The Commission has issued the enclosed Amendment No. 96 to Facility Operating License No. DPR-23 for the H. B. Robinson Steam Electric Plant Unit No. 2. This amendment consists of changes to the Technical Specifications in response to your request dated July 1, 1985, as supplemented by letters dated November 8 and 26, 1985.

The amendment revises the Appendix A Technical Specifications to incorporate a change to the graph of "Normalized Axial Dependence Factor For F_q versus Elevation" depicted in Figure 3.10-3.

Amendment No. 96
License No. DPR-23

SAFETY EVALUATION BY THE OFFICE OF NUCLEAR REACTOR REGULATION
RELATED TO AMENDMENT NO. 96 TO FACILITY OPERATING LICENSE NO. DPR-23
CAROLINA POWER AND LIGHT COMPANY
H. B. ROBINSON STEAM ELECTRIC PLANT, UNIT NO. 2
DOCKET NO. 50-261

Figure 3.10-3 Normalized Axial Dependence Factor for F_q versus Elevation
(Peak $F_q = 2.32$)

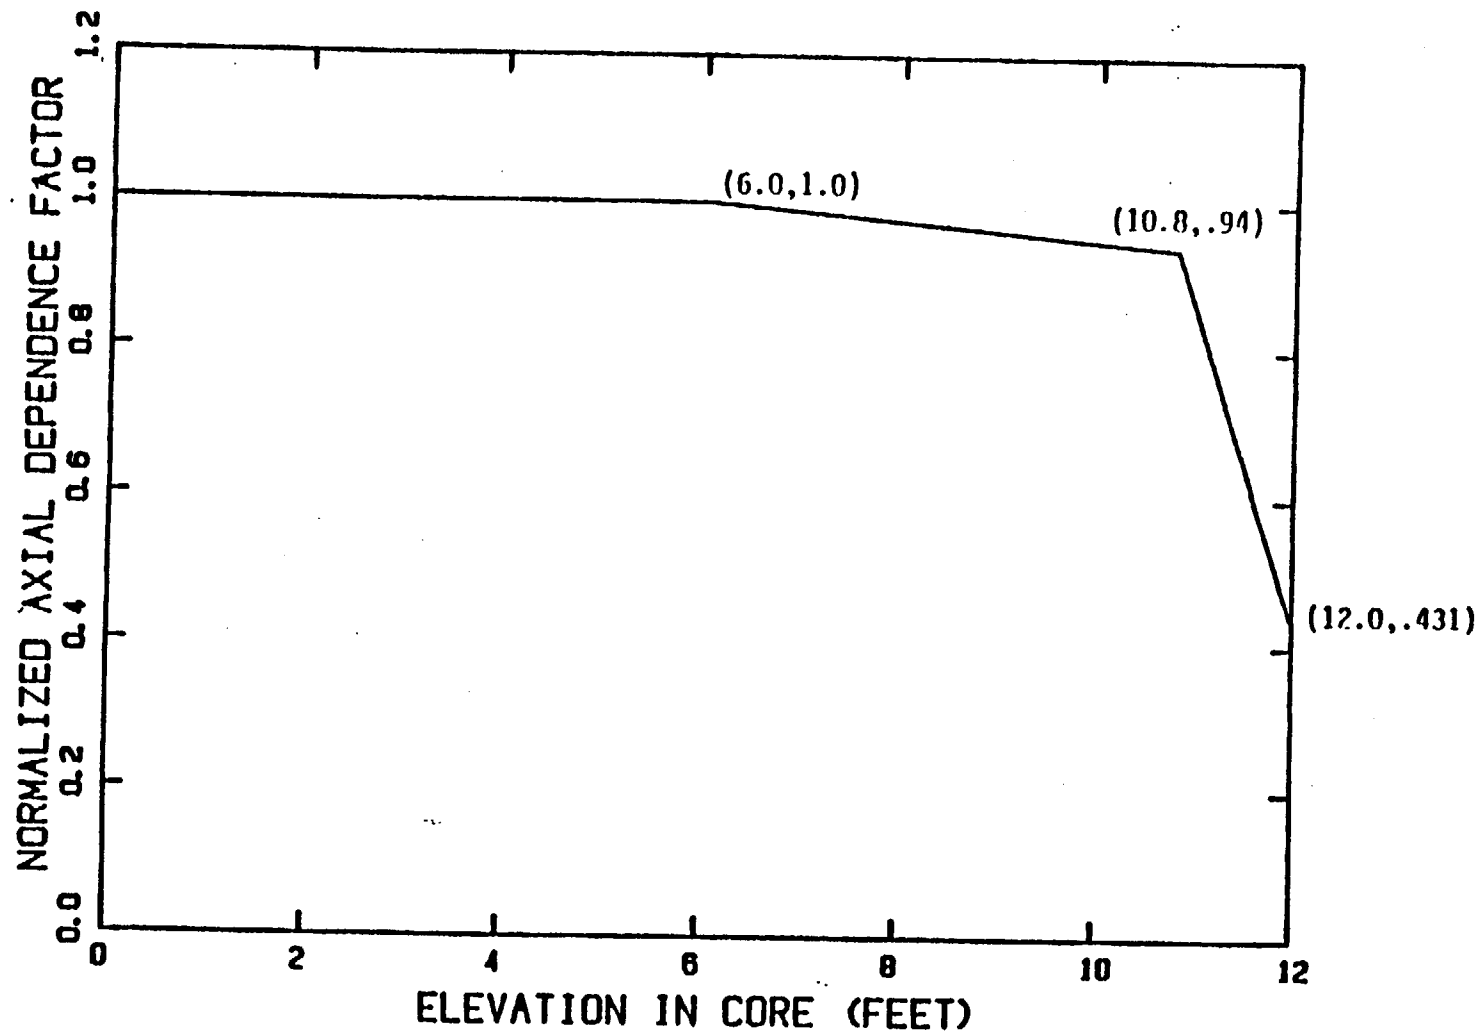
The licensee, the Carolina Power and Light Company (CP&L), for (HBR-2) has proposed, in Reference 1, a revision to the HBR-2 Technical Specifications. The change specifically addresses a change to the graph of "Normalized Axial Dependence Factor for F_q versus Elevation" as depicted in Figure 3.10-3 of the Technical Specifications. This graph is also referred to as the $K(z)$ curve.

As part of the proposed modification to the $K(z)$ curve, the licensee altered the third line segment. This portion of the $K(z)$ curve is applied over the 10.8 to 12 foot core elevations. This portion of the $K(z)$ curve is utilized to assure that the consequences of small break LOCAs satisfy the requirements of 10 CFR 50.46. In References 2 and 3, the licensee provided the results of small break LOCA analysis performed by Westinghouse to demonstrate conformance to 10 CFR 50.46.

In performing the analysis, Westinghouse utilized a top-skewed power shaped which followed the proposed $K(z)$ curve from 10 to 10.8 feet. Above 10.8 feet, the power shape used linearly decreased to an allowed F_q at 12 feet of 1.5. This power shape allows linear heat generation rates in excess of the proposed $K(z)$ curve. Specifically, the proposed curve linearly decreases above the 10.8 feet elevation to an F_q of 1.0 at 12 feet.

Our review of the licensee's analysis has concluded that the revised third line segment of the proposed K(z) curve provides compliance to 10 CFR 50.46. Specifically, we note that the licensee has utilized an approved evaluation model which complies with the requirements of Appendix K to 10 CFR 50.46. We have also examined the similarity in fuel rod designs and have concluded that use of the OFA design would result in a similar cladding heat up during the core uncover phase. In addition, because of the substantially higher linear heat generation rates utilized in the analysis any impact of the difference in fuel design has been conservatively addressed. Thus, since the analysis demonstrates conformance to 10 CFR 50.46, we find the proposed Technical Specification change for the K(z) curve to be acceptable.

Based upon the licensee revised large and small break evaluations, we find the proposed modification to the Technical Specification K(z) curve to be acceptable. In addition, the revised analyses demonstrate the acceptability of the current Technical Specification F_Q value of 2.32. Thus, the administrative limits imposed by the licensee in Reference 8, and approved by the NRC in Reference 9, are no longer needed. Our conclusions apply only up to the steam generator tube plugging limit of 5% utilized in the analysis.

Figure 3.10-3 Normalized Axial Dependence Factor for F_q versus Elevation
(Peak $F_q = 2.32$)

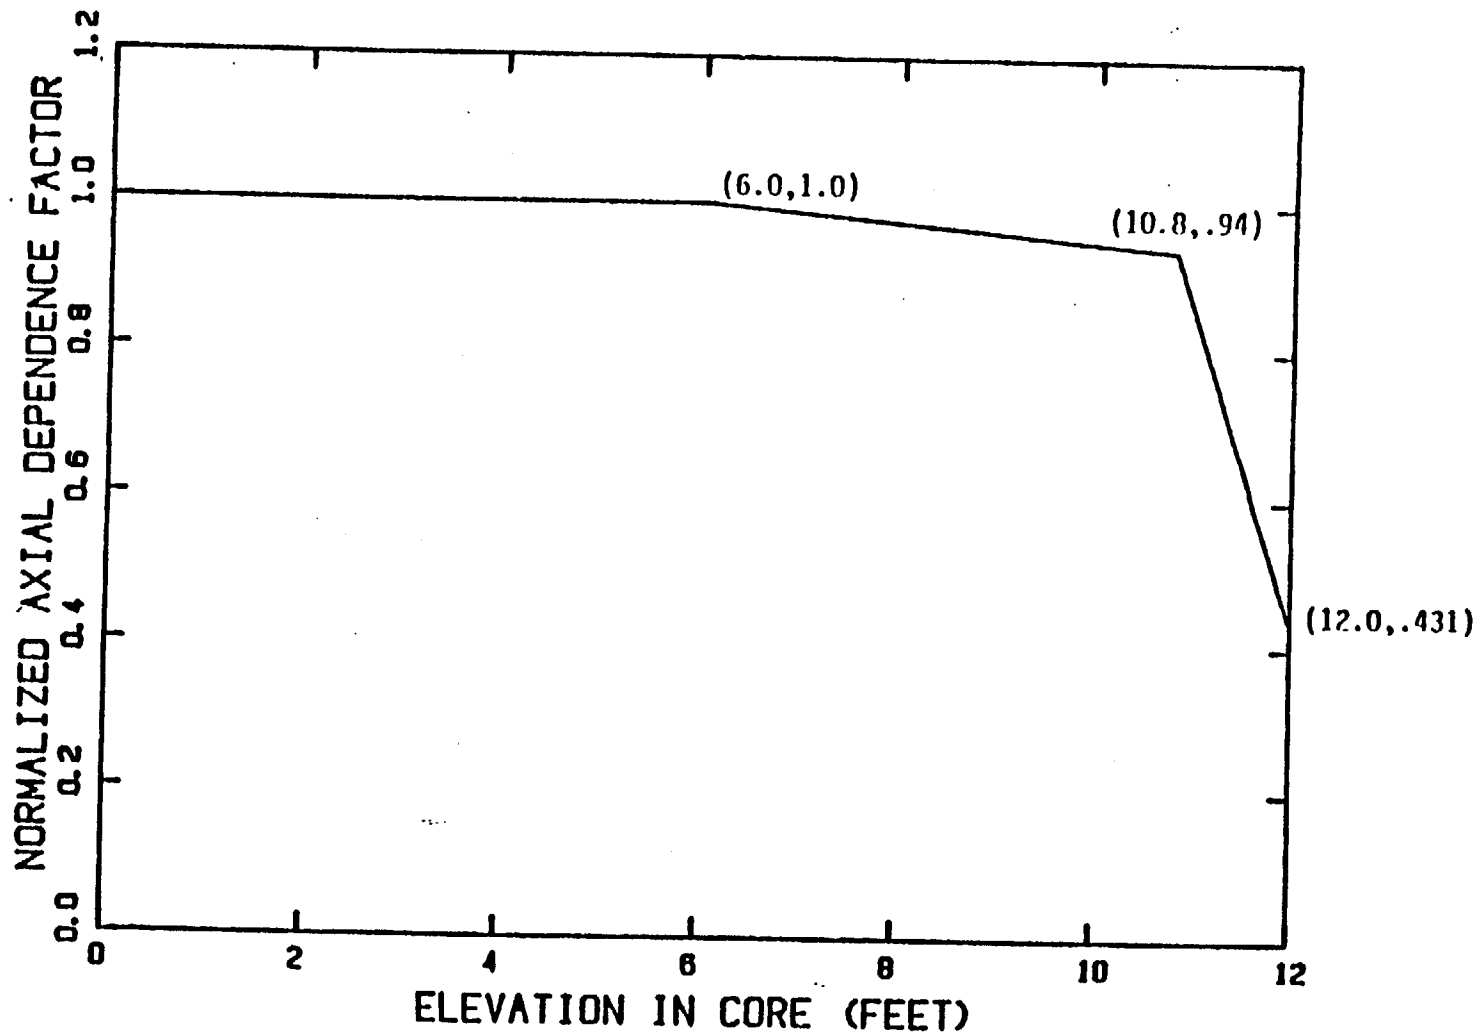
The amendment revises the Appendix A Technical Specifications to incorporate a change to the graph of "Normalized Axial Dependence Factor For F_q versus Elevation" depicted in Figure 3.10-3.

The licensee, the Carolina Power and Light Company (CP&L), for (HBR-2) has proposed, in Reference 1, a revision to the HBR-2 Technical Specifications. The change specifically addresses a change to the graph of "Normalized Axial Dependence Factor for F_q versus Elevation" as depicted in Figure 3.10-3 of the Technical Specifications. This graph is also referred to as the $K(z)$ curve.

As part of the proposed modification to the K(z) curve, the licensee altered the third line segment. This portion of the K(z) curve is applied over the 10.8 to 12 foot core elevations. This portion of the K(z) curve is utilized to assure that the consequences of small break LOCAs satisfy the requirements of 10 CFR 50.46. In References 2 and 3, the licensee provided the results of small break LOCA analysis performed by Westinghouse to demonstrate conformance to 10 CFR 50.46.

In performing the analysis, Westinghouse utilized a top-skewed power shape which followed the proposed K(z) curve from 10 to 10.8 feet. Above 10.8 feet, the power shape used linearly decreased to an allowed F_q at 12 feet of 1.5. This power shape allows linear heat generation rates in excess of the proposed K(z) curve. Specifically, the proposed curve linearly decreases above the 10.8 feet elevation to an F_q of 1.0 at 12 feet.

Our review of the licensee's analysis has concluded that the revised third line segment of the proposed K(z) curve provides compliance to 10 CFR 50.46. Specifically, we note that the licensee has utilized an approved evaluation model which complies with the requirements of Appendix K to 10 CFR 50.46. We have also examined the similarity in fuel rod designs and have concluded that use of the OFA design would result in a similar cladding heat up during the core uncover phase. In addition, because of the substantially higher linear heat generation rates utilized in the analysis any impact of the difference in fuel design has been conservatively addressed. Thus, since the analysis demonstrates conformance to 10 CFR 50.46, we find the proposed Technical Specification change for the K(z) curve to be acceptable.

Based upon the licensee revised large and small break evaluations, we find the proposed modification to the Technical Specification K(z) curve to be acceptable. In addition, the revised analyses demonstrate the acceptability of the current Technical Specification F_Q value of 2.32. Thus, the administrative limits imposed by the licensee in Reference 8, and approved by the NRC in Reference 9, are no longer needed. Our conclusions apply only to the steam generator tube plugging limit of 5% utilized in the analysis.
